## Arlington Zoning Board of Appeals

**Date:** Tuesday, October 12, 2021  
**Time:** 6:30 PM  
**Location:** Conducted by remote participation  
**Additional Details:**

To: Zoning Board of Appeals  
From: Jennifer Raitt, Director, Dept. of Planning and Community Development/kl  
Date: 10/5/2021  
RE: Docket 3666 – 14-16 Egerton Rd; Special Permit under Zoning Bylaw Sections 8.1.3(B) (Nonconforming Single-Family or Two-Family Dwellings) and 6.1.10 (A) (Location of Parking Spaces)

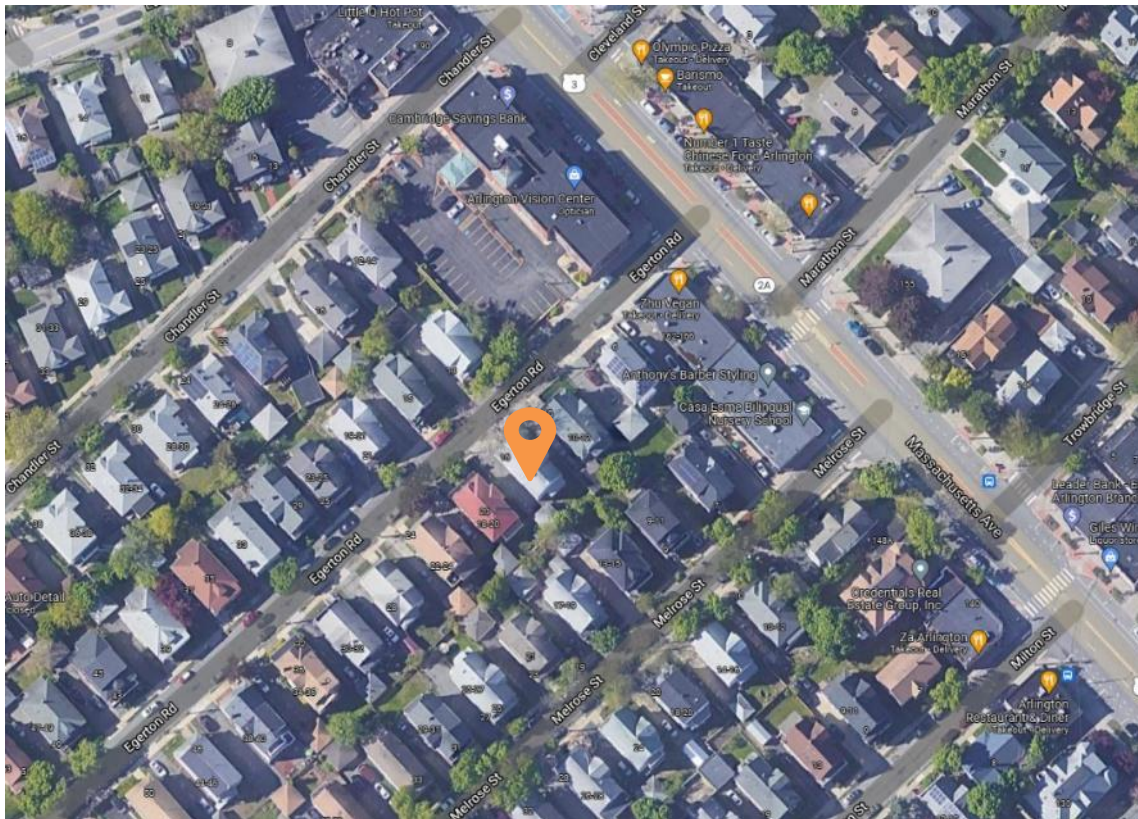
The applicant, Sean Lyons, seeks a Special Permit in accordance with Sections 8.1.3(B) (Nonconforming Single-Family or Two-Family Dwellings) and 6.1.10 (A) (Location of Parking Spaces) of the Zoning Bylaw. The applicant seeks construct a half-story addition by expanding their existing attic with a shed dormer on the northeast side of the structure. The addition would increase the total square footage of the structure from 2,740 to 3,485 square feet (+745 square feet). It is unclear if addition meets the definition of a half story, as the applicant has not identified in the plans or elevations what proportion of the third story will have a height greater than seven feet.

The applicant also seeks to add a second driveway along Egerton Road to create a second driveway along the northeast side of the structure, although a site plan indicating the design, complete dimensional details, and total number of parking spaces to be added through the proposed parking area has not been provided.

The proposal would provide additional living space. The second proposal would provide a second driveway for the property and create two distinct parking areas. It is unclear whether adding a second driveway along Egerton Road would present a hazard to pedestrian, bicycle, or vehicular safety.

The Department of Planning and Community Development (DPCD) recommends that the applicant consider the described aesthetic improvements to the plans. DPCD also recommends that the Zoning Board of Appeals requests details regarding the following:

- Details regarding the dimensions of the third story of the structure to ensure that the addition meets the Zoning Bylaw's definition of a half story.
- A site plan indicating location and dimensions of the proposed second parking area and curb cut, as well as identification of any existing landscaped or usable open space.

DPCD notes that the current structure meets the minimum number of parking spots required by the Zoning Bylaw and recommends that the applicant consider reconfiguring the existing parking area to provide additional spaces, should they be required.

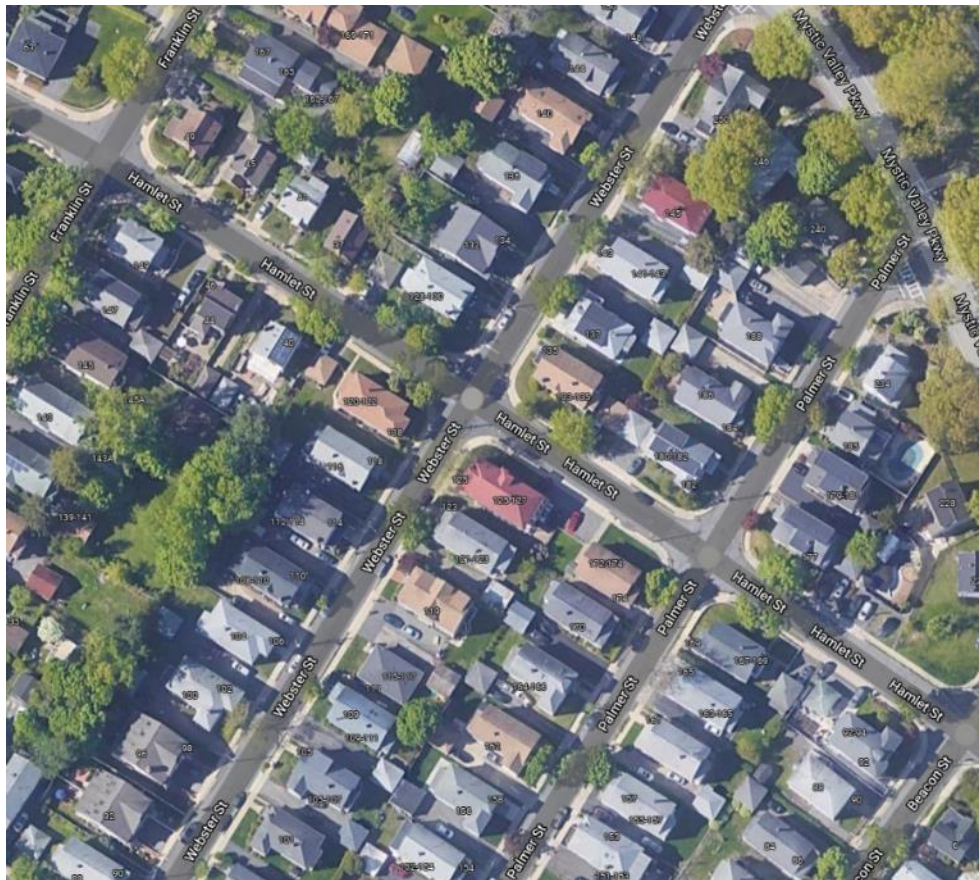
- Information on the provided worksheets is not consistent with notes on dimensional details provided on the two sets of floor plans.
- The applicant has completed forms for a Special Permit, however the request to create the nonconforming third floor cannot be accommodated through the granting of a Special Permit.

The Department of Planning and Community Development (DPCD) is unable to provide a recommendation based on the materials provided by the applicant. The Zoning Board of Appeals should request the following materials from the applicant prior to rendering a decision:

- Updated calculations of landscape and usable open space as a proportion of the existing and proposed gross floor area.
- A narrative explanation of how the proposal meets the four Variance criteria described in MGL Chapter 40A, §10, should the applicant continue to request a Variance. In seeking a Variance, the applicant must complete the following forms:
  - Request for Variance / Town of Arlington
  - Variance Criteria
